## **Proposed amendment to UN Regulation No. 13**

The text reproduced below was prepared by the experts of the informal working group ACV for the amendment of Regulation No. 13. This is to enable the use of automatic couplings systems. Outcome of the 8<sup>th</sup> meeting.

**Figure A: Point-to-point connection ECU Tractor (E1) and ECU Trailer (E10) via ACV**

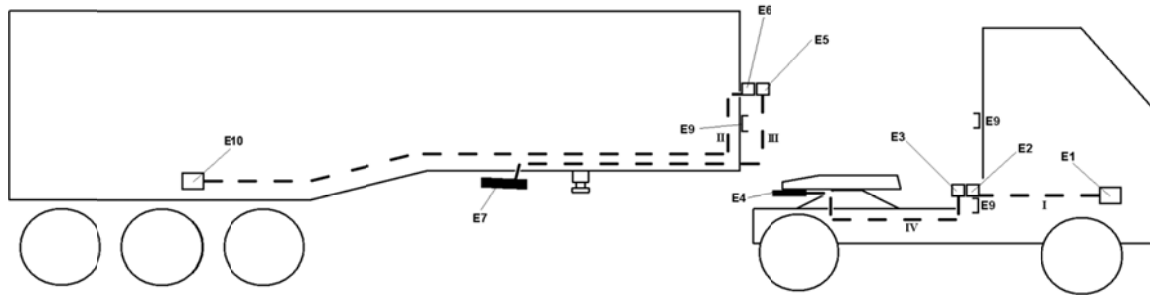
**Automated connection mode: No coiled cables connected, Connection between E1 and E10 when E4 and E7 are connected (i.e. when fifth wheel coupled)**

**Figure B: Point-to-point connection ECU Tractor (E1) and ECU Trailer (E10) via coiled cable**

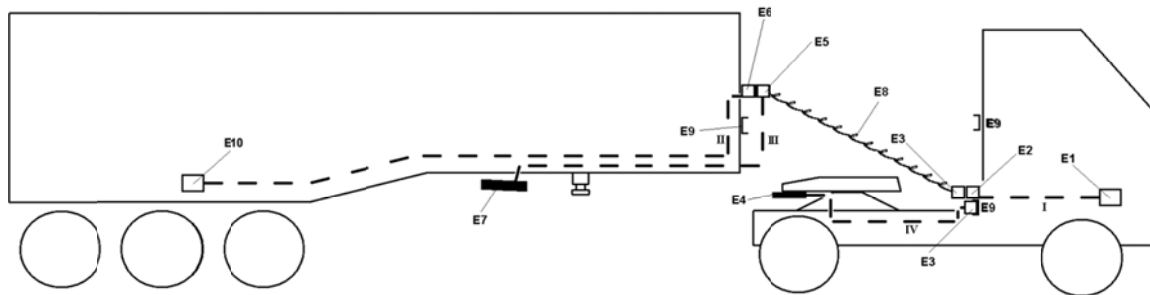
**Manual mode: Coiled cables connected, Connection between E3 and E4 as E5 and E7 are not in use**

**Figure C: Point-to-point connection ECU Tractor (E1) and ECU Trailer (E10) when Fifth Wheel is closed**

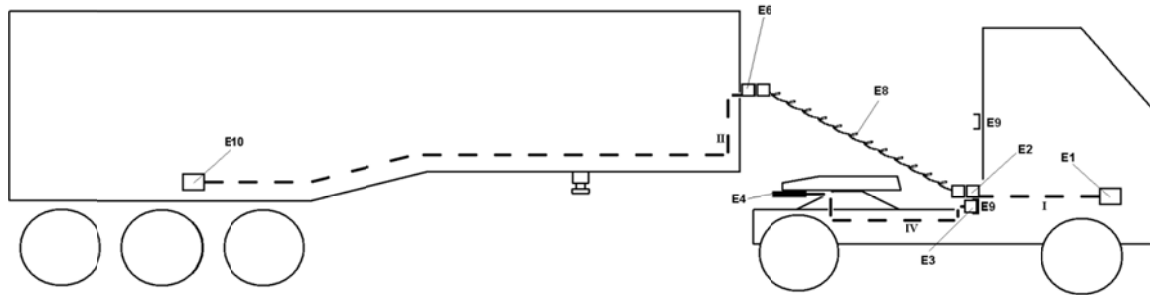
Coiled cables connected, Line E3 to E4 is not in use

**Figure D: Point-to-point connection ECU Tractor (E1) and ECU Trailer (E10)**

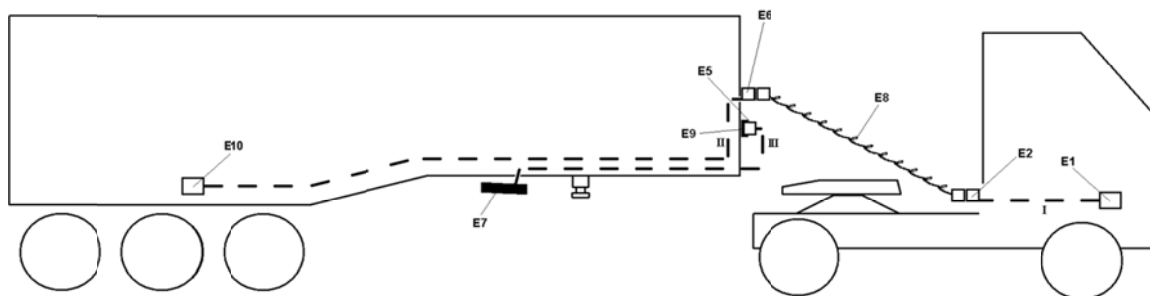
Coiled cables connected, Line E5 to E7 is not in use

**Figure E: Pneumatic connection Tractor and Trailer via ACV**

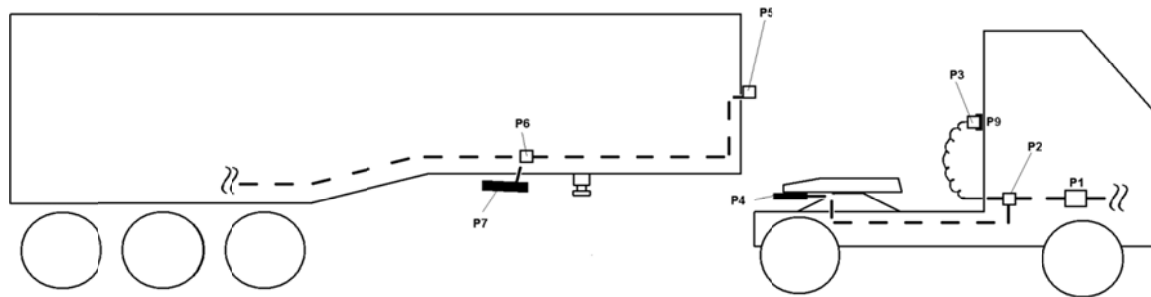
**Automated connection mode: No coiled cables connected, Connection between tractor and trailer when P4 and P7 are connected (i.e. when fifth wheel coupled)**

**Figure F: Pneumatic connection Tractor and Trailer via coiled tube**

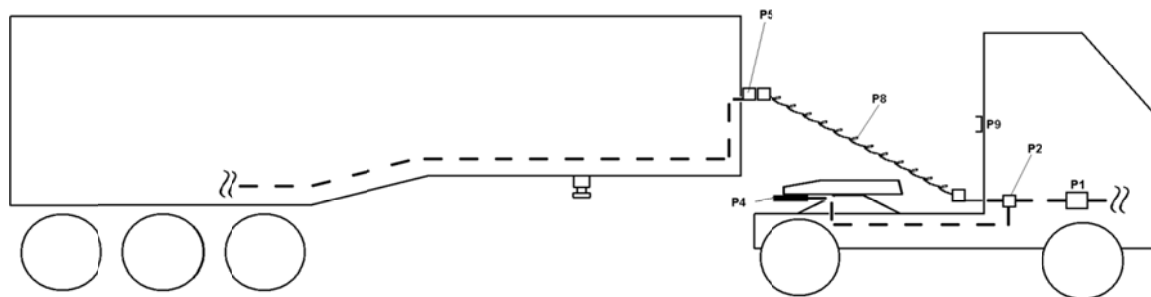
**Coiled tubes connected, Line P2 to P6 is not in use**

**Figure G: Pneumatic connection Tractor and Trailer via coiled tube**

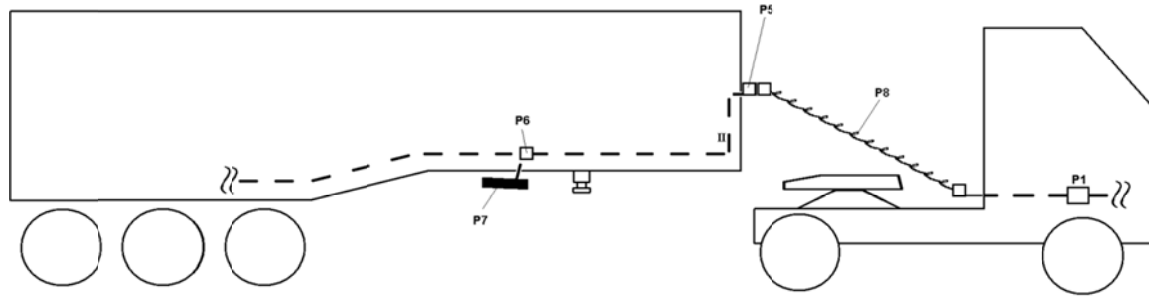
Coiled tubes connected, Line P2 to P6 is not in use
